Final EIR

800 Carlisle Way Well & Water Tank

File No. 2022-7041

February 2026

REPLACE Figure 2.2-1: Proposed Site Plan and Figure 2.2-2: Proposed Project Elevations with the figures below.

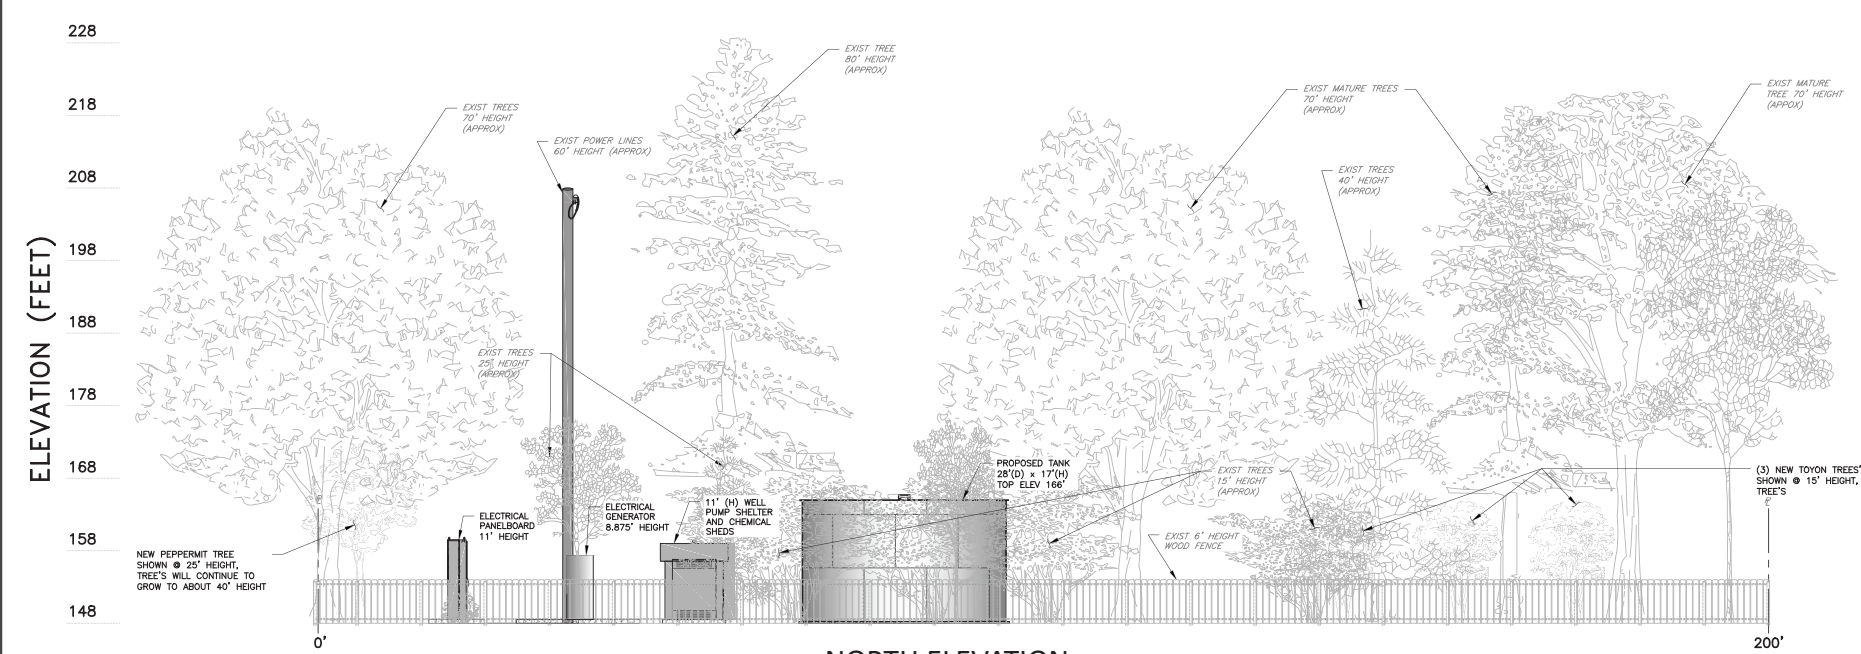
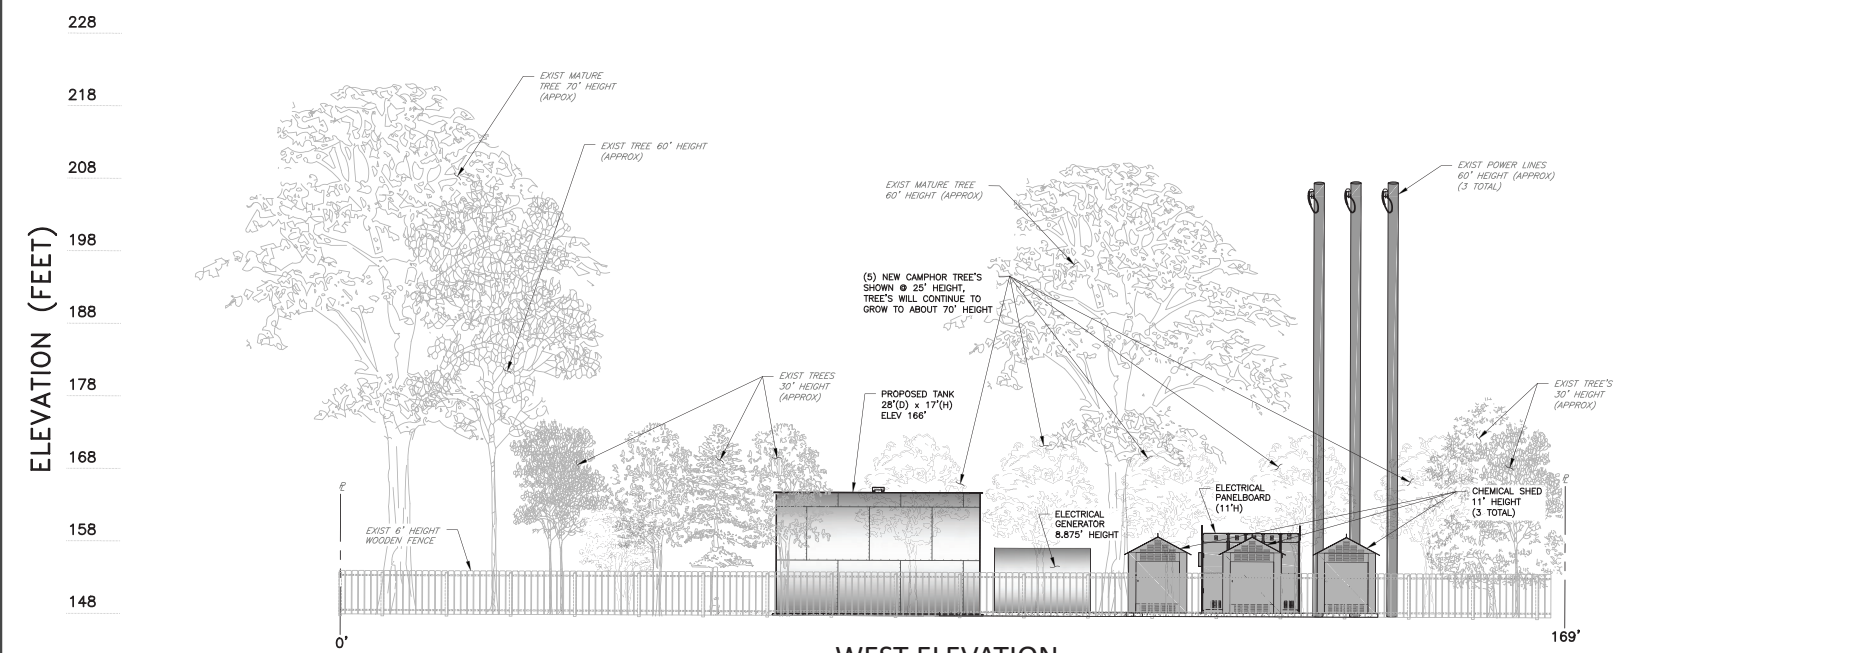
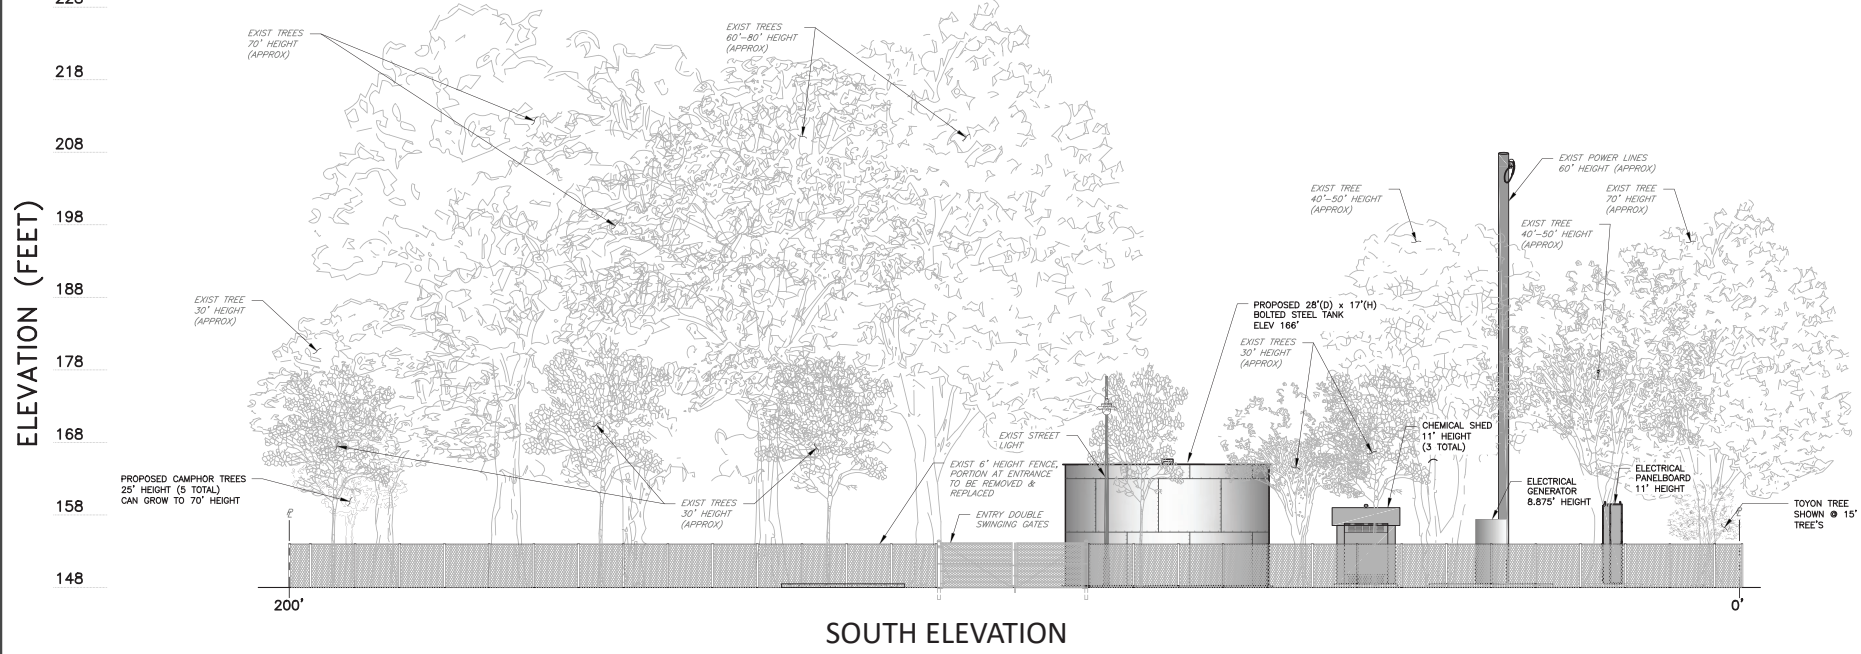
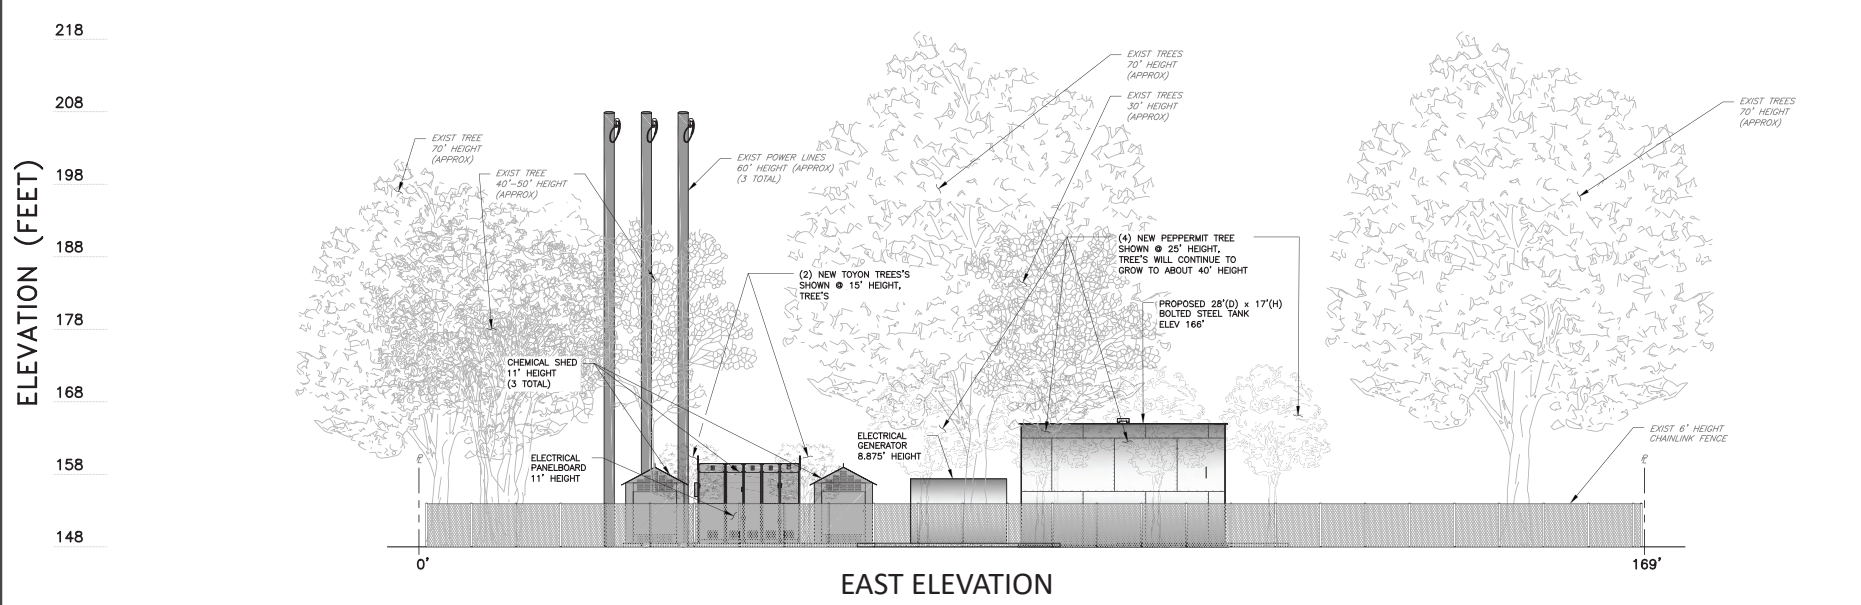
Response E.15: Subsequent to circulation of the Draft EIR, the proposed tank height was revised to be a maximum of 17 feet, which is consistent with allowed maximum height in the zoning district and the maximum height of residences in the surrounding neighborhood. Potential impacts to privacy of surrounding residences are not considered an impact under CEQA; therefore, a detailed discussion of those potential impacts was not included in the Draft EIR or the associated appendices. However, as discussed on page 23 of the Initial Study included as Draft EIR Appendix A, the project is subject to the City's design review process, which would ensure the project incorporates appropriate design measures (such as setbacks and landscaping) to reduce potential visual impacts and be compatible with the existing neighborhood character. Refer to Section 5.0 Draft EIR Text Revisions for additional details regarding the revised project description. This comment does not raise any issues about the adequacy of the Draft EIR.

Figure 7-3 Modeled Noise Mitigation Sound Barrier Layout at Proposed Well Site
Appendix B, p28/73

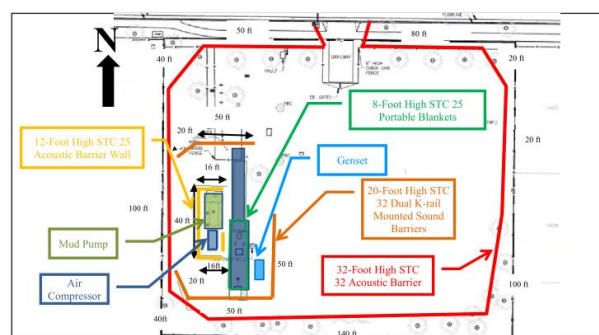
Comment H.4: Noted to facilitate the discussion in (b): With mitigation measure DEIR MM NOI-1.1 with acoustic barriers installed as shown in Appendix B Fig. 7-3, reproduced here, modeling shows that for all except two of the nearby residences, the modeled noise levels in DEIR Table 3.1-4 can be below 50 dBA , satisfying the night-time noise limit. Hotel vouchers can be provided to the two.

Response H.4: This comment is acknowledged. The comment does not raise any specific issues about the adequacy of the Draft EIR; therefore, no further response is required.
